**PLANNED UNIT DEVELOPMENT
STAFF REPORT****Date: February 3, 2011****DEVELOPMENT NAME**

Apostolic Overcoming Holy Church of God

LOCATION2257 St. Stephens Road
(Southwest corner of St. Stephens Road and Allison Street,
extending to the Northwest corner of St. Stephens Road and
Vetter Street)**CITY COUNCIL
DISTRICT**

CONTEMPLATED USEPlanned Unit Development Approval to amend a
previously approved Planned Unit Development to allow
multiple buildings on a single building site.**TIME SCHEDULE
FOR DEVELOPMENT**

SITE PLAN

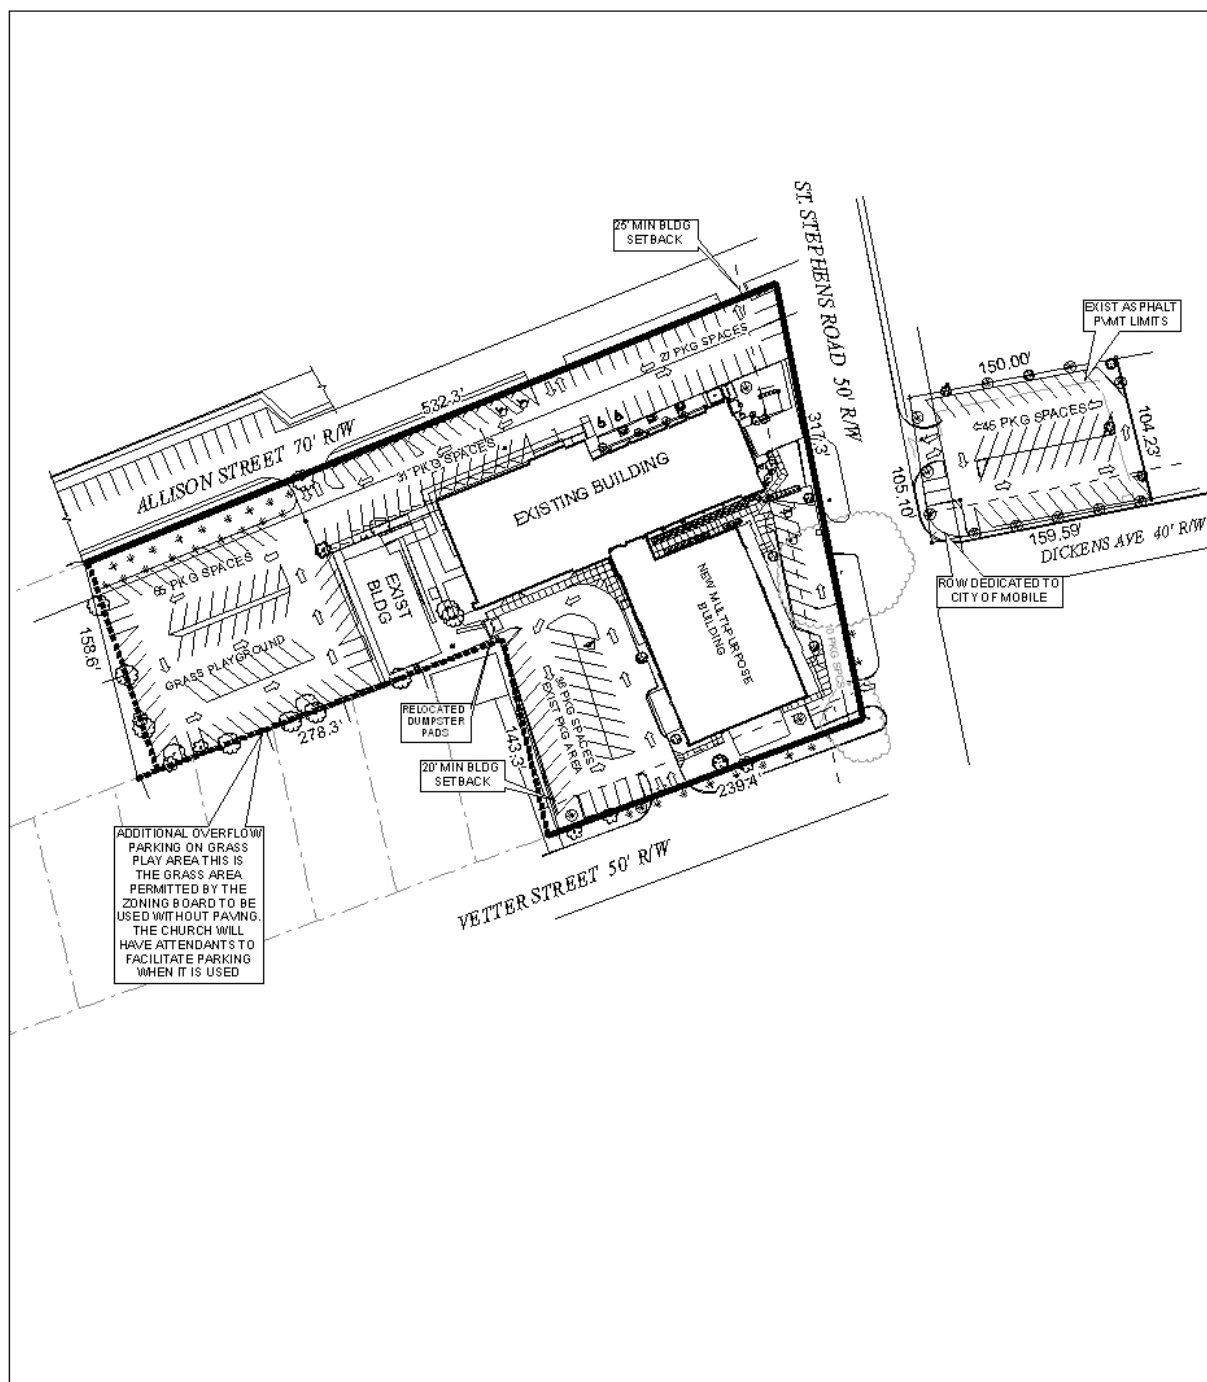
Another point of concern is the location of the fenced mechanical yard within the required 20' side street yard setback along Vetter Street. The site plan erroneously labels this as a 25' setback, but the approval of Phillips Temple A.O.H. Subdivision in 2001 required a 25' setback only along St. Stephens Road and Allison Street; therefore, a 20' setback is required along Vetter Street. The site plan should be revised to reflect this. As no structure (including HVAC equipment and generators) or fence above 3' high can be built within the required setback, the mechanical yard should be relocated to a compliant location, or a setback variance sought, or a note should be placed on the site plan indicating that nothing higher than 3' above grade will be constructed within this area.

The site plan indicates a public sidewalk only along Allison Street. All new development requires public sidewalks to be installed along all street frontages; therefore, the site plan should be revised to illustrate proposed public sidewalks where lacking or a sidewalk waiver should be submitted.

The revised site plan and/or narrative clear most of the issues causing concerns with the initial review. There are three remaining items, tree planting areas, parking lot trees, and public sidewalks, which require further attention. The off-site parking area does not appear to have adequate area along the Dickens Avenue frontage to allow tree root-ball planting entirely within the property boundary. Urban Forestry has determined that a Right-of-Way Permit from the Engineering Department is required prior to the planting of new trees along the Dickens Avenue right-of-way. The off-site parking area is short one parking area tree, but there is an available island in the parking area which would allow one under-story tree to be planted; therefore, the site plan should be revised to add one more under-story parking tree. The tree planting plan for

the main site indicates trees proposed to be planted within the right-of-way. Urban Forestry has determined that full compliance with the landscaping and tree planting requirements of the Zoning Ordinance should be coordinated with Urban Forestry, and that a Mobile Tree Commission Permit is required before removing existing trees from the city right-of-way along Vetter Street for construction of the proposed driveway. The site plan should be revised to indicate tree planting compliance for both sites to be coordinated with Urban Forestry.

The site plan still does not indicate public sidewalks to be constructed where currently lacking. The revised narrative indicates that a Sidewalk Waiver will be submitted due to existing trees which were planted to meet landscape requirements of previous approvals for the site.

- 1) revision of the landscaping and tree planting plan to show full compliance with the Zoning Ordinance, to be coordinated with Urban Forestry;*
- 2) obtaining of a Mobile Tree Commission Permit before removing existing trees from the city right-of-way along Vetter Street for construction of the proposed driveway;*

- 3) obtaining of a Right-of-Way permit for the planting of trees encroaching into the right-of-way along Dickens Avenue if such trees cannot be planted entirely within the property boundaries, to be coordinated with Urban Forestry;*

- 4) revision of the site plan to provide public sidewalks along all street frontages where lacking, or the submission of a sidewalk waiver application;*

- 5) placement of a note on the site plan stating that any equipment in the mechanical yard within the 20’ setback along Vetter Street is to be no higher than 3’ above grade;*

- 6) placement of a note on the site plan stating that the driveway number, size, location, and design are to be approved by Traffic Engineering and ALDOT and conform to AASHTO standards, and all one-way aisles are to be signed and marked;*

- 7) retention of the note on the site plan stating “lighting shall be provided and maintained during the operation of the parking area, and shall be so arranged that the source of light does not shine directly into adjacent residential properties or traffic”;*
